2572 MEK

Ground Water Monitoring and closure request Report.

SINCLAIR STATION - RICHFIELD, MINNESOTA

ENECOTECH		GROUNDWATER ELEVATION CONTOUR MAP (3/08/91) SINCLAIR SERVICE STATION 7753 PORTLAND AVE. SOUTH RICHFIELD, MINNESOTA
BLOOMINGTON, MINNESOTA		
PROJECT	SINCLAIR-PORTLAND AVE

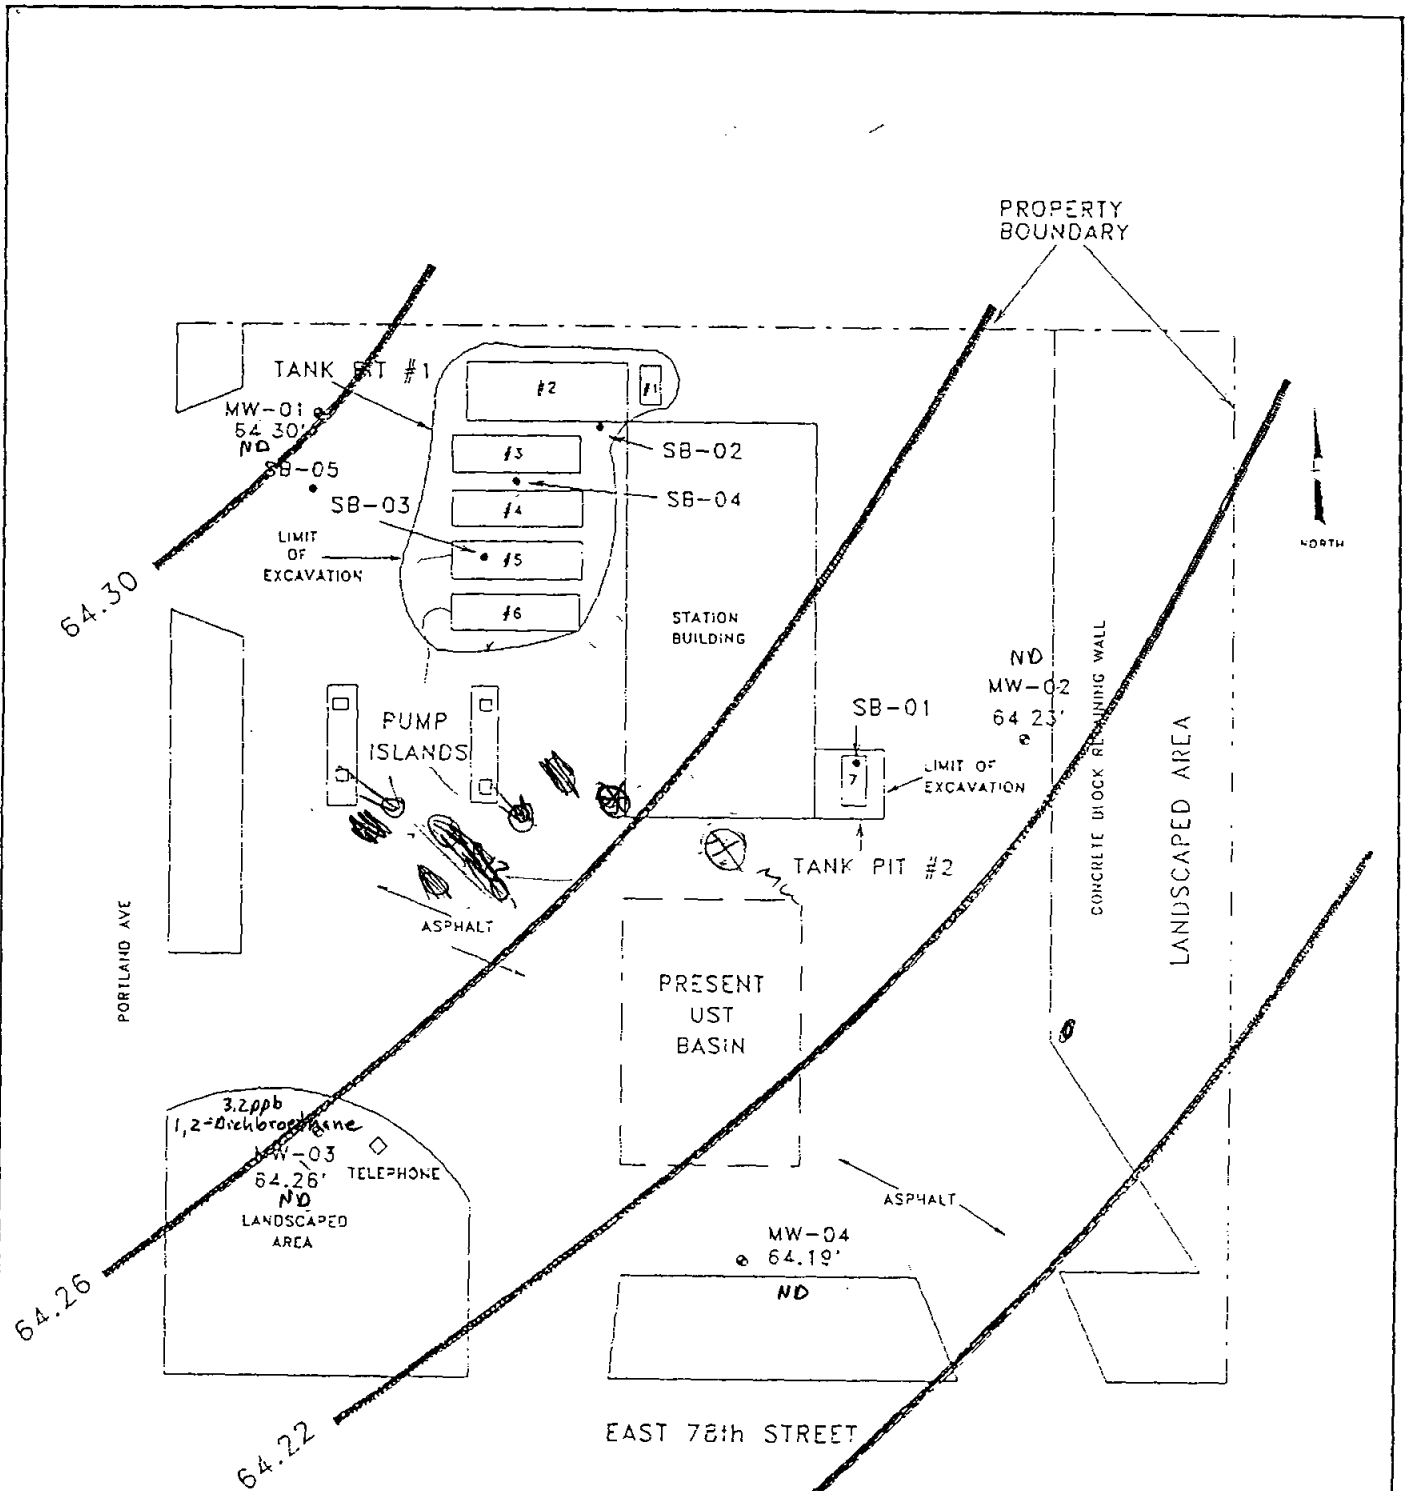
Water Table 35'

GW flows South east

3. An adequate number of monitoring well(s) should be installed to define the downgradient extent of ground water contamination. The additional monitoring well(s) should be installed downgradient of MW-3. Please notify MPCA hydrogeologist Larry Quandt (612-297-8602) of the proposed location and construction of the downgradient monitoring well(s) a minimum of 10 working days prior to installation.
